RE: **Lot 10 Block 2 Unit 19 SAD 228
7801 Aguila Rd. NW
Volcano Cliffs Subdivision
Revised Grading and Drainage Plan
Engineers Stamp Date 8/3/2021 (D10D003G10)**

Based upon the information provided in your submittal received 8/3/2021, this plan is approved for Grading Permit and SO-19.

7801 AGUILAR	DRAWN BY WCVJ
	GRADING AND DRAINAGE PLAN	DATE 8-01-21
8/3/21		21021075-LAYOUT-8-01-21
DAVID SOULE P.E. #14522	Rio Grande Engineering 1606 CENTRAL AVENUE SE SUITE 201 ALBUQUERQUE, NM 87106 (505) 972-9398	SHEET #
		JOB # 21021075

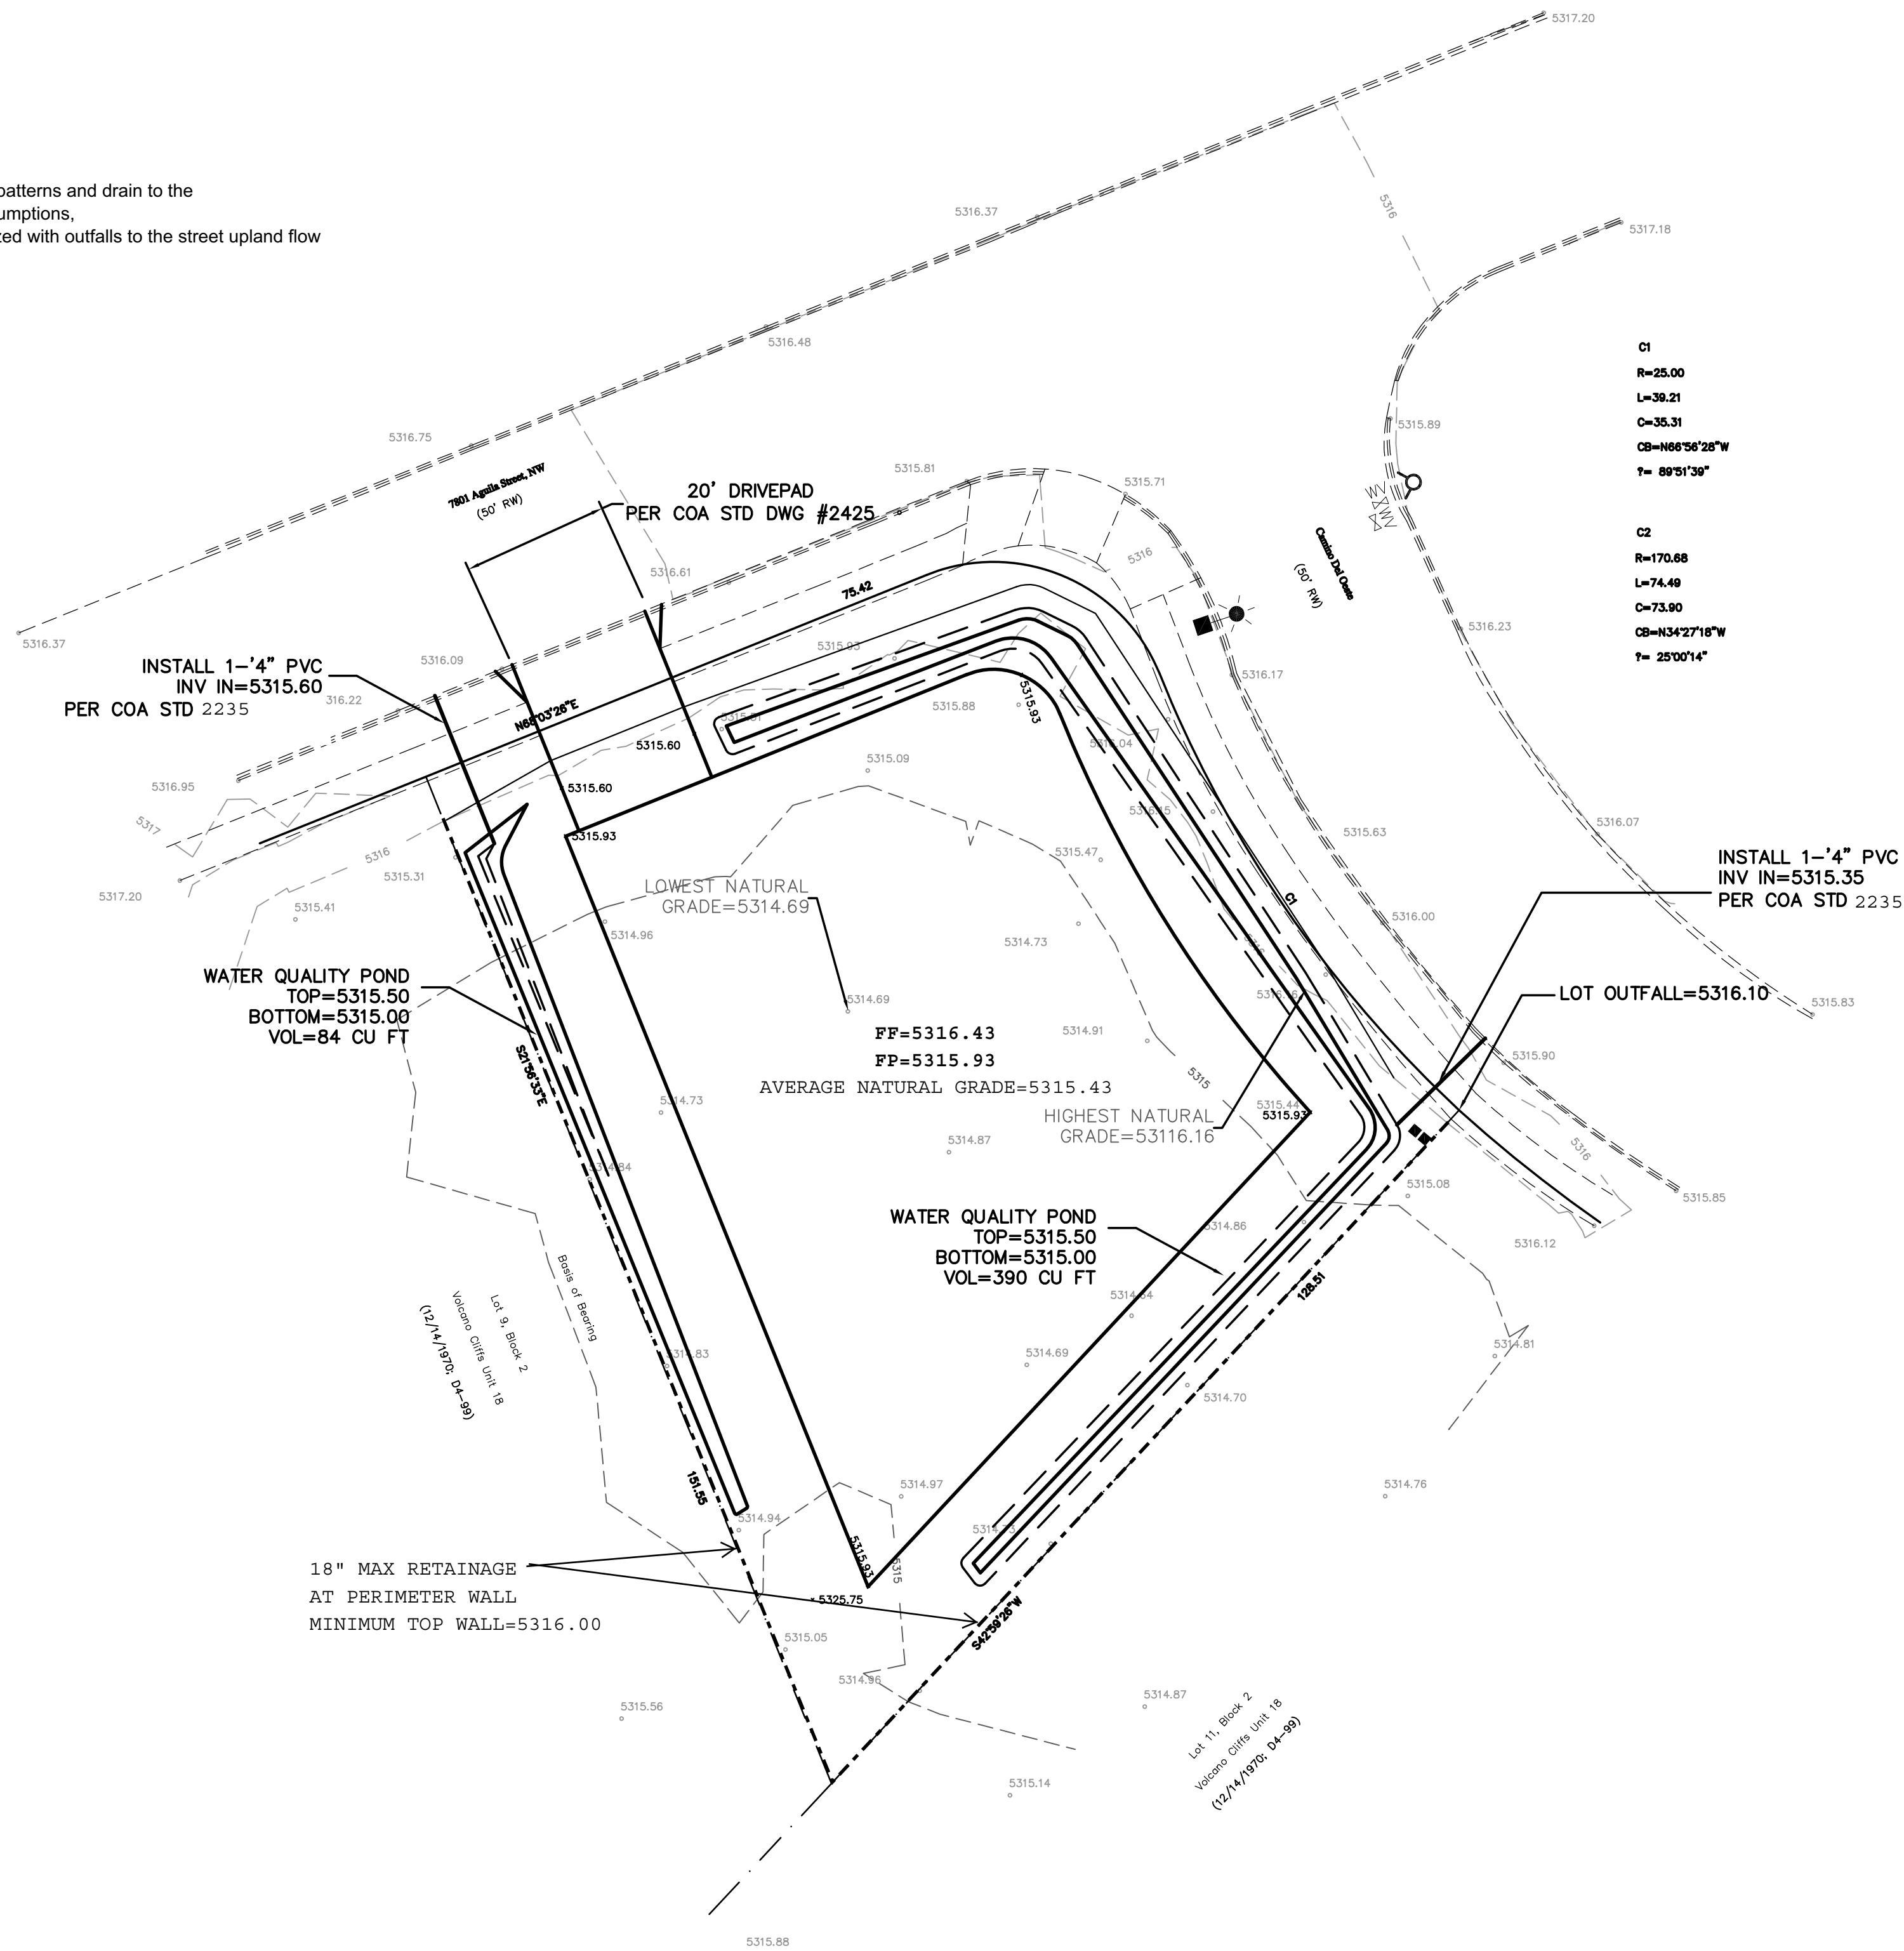
Prior to Building permit approval a Pad Certification will be required, provided by the Engineer or a registered Land Surveyor.

Advise the owner contractor not to use dirt as a ramp to climb the curb, use lumber or crusher fines for this purpose.

Reiterate to the Owner/Contractor that a separate permit for a garden/retaining wall must be obtained with the approved G&D plan and Pad Certification. Also, if a swimming pool is to be placed after this approval a new grading and drainage plan will need to be resubmitted showing the changes for the land treatments.

Prior to Certificate of Occupancy release, Engineer Certification per the DPM checklist is required.
